Product Change Notification

1. ECN #: 279234

- LPHS - LPHS ASSEMBLY
- ET60S - ET60S SOCKET POWER ASSEMBLY
- HSEC8 - .8mm HIGH SPEED, DUAL VERTICAL MOUNT, EDGE CARD ASSEMBLY

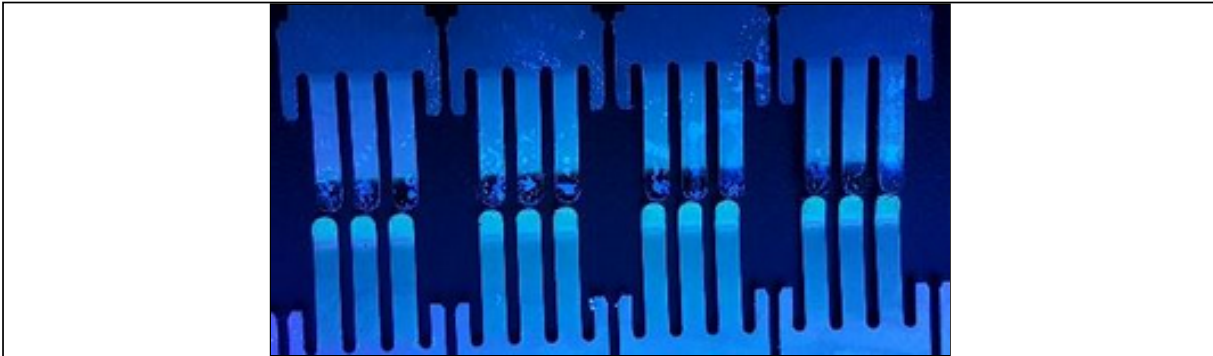
Adding PPE connector lubricant to -S plating to aid with high mating/unmating forces.

The lubricant can be detected under a UV light source.

The lubricant is shown on the top row under the UV light source. The bottom strip is not lubricated.
